# KITTITAS COUNTY

### MEMORANDUM

TO: Jeff Watson  
FROM: Christina Wollman, Planner II *sw*  
DATE: December 1, 2010  
SUBJECT: Kittitas County Fire District #2 PF-10-00004

Road Approach Design Template D1  
Exhibit 1340-5

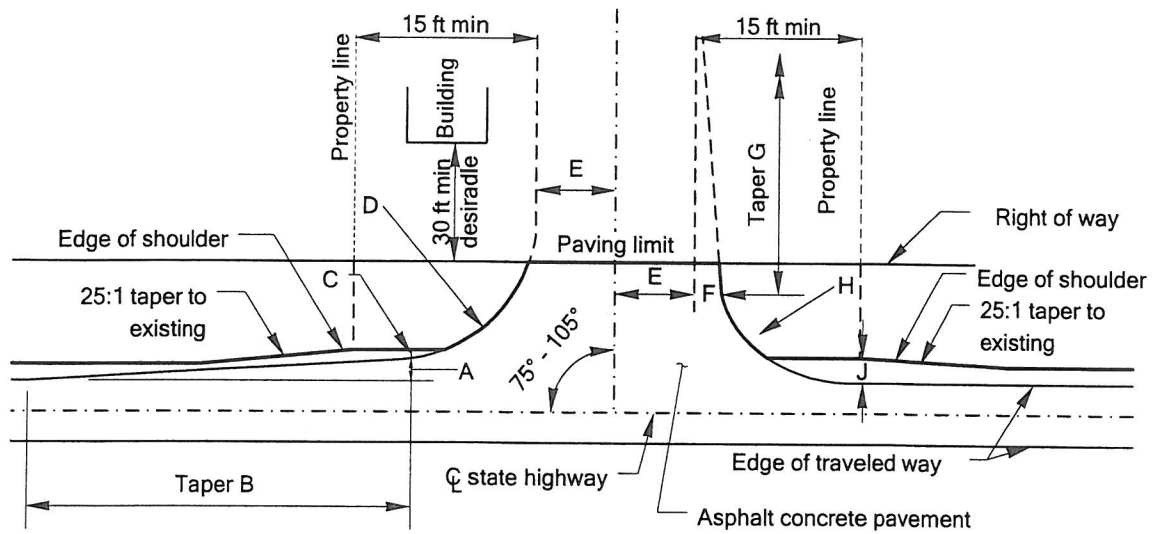
- A. The site is currently addresses as 890 Cleman Road. The approach is currently constructed to agricultural standards. With the construction of the fire station, the approach must be improved to meet commercial standards as shown in WSDOT Design Manual Exhibit 1340-5 (attached). Prior to performing any work within the county right-of-way, an access permit must be applied for from Public Works.
